## Product Change Notification

### Bourns® Sensors & Controls Product Line Model 91/96 Terminal Length Change

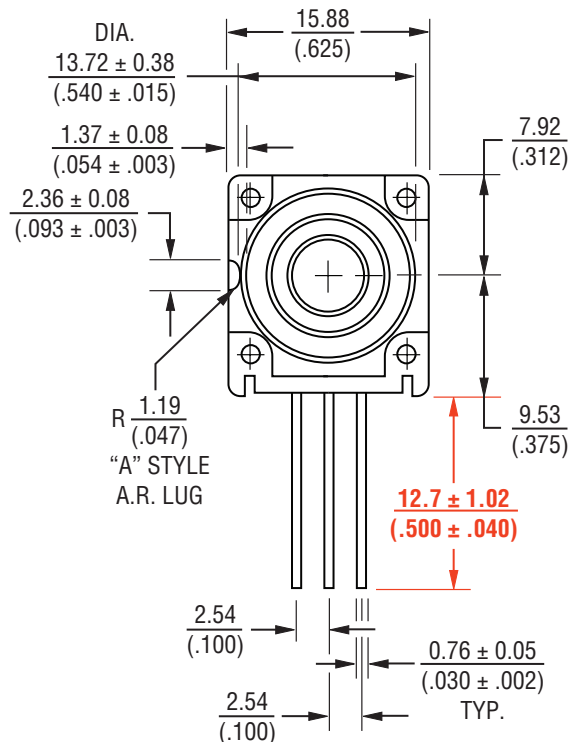
Bourns® Sensors & Controls Product Line is announcing a change in fit to the terminal lengths on our [Model 91](#) and [96](#) – 5/8" Single-Turn Panel Controls.

Both models have been supplied with  $0.602" \pm .022"$  (15.29 mm  $\pm$  .56 mm) terminals. Effective November 1, 2011 terminals will conform to a new standard length of  $0.500" \pm .040"$  (12.7 mm  $\pm$  1.02 mm). See the diagram below referencing the dimension:
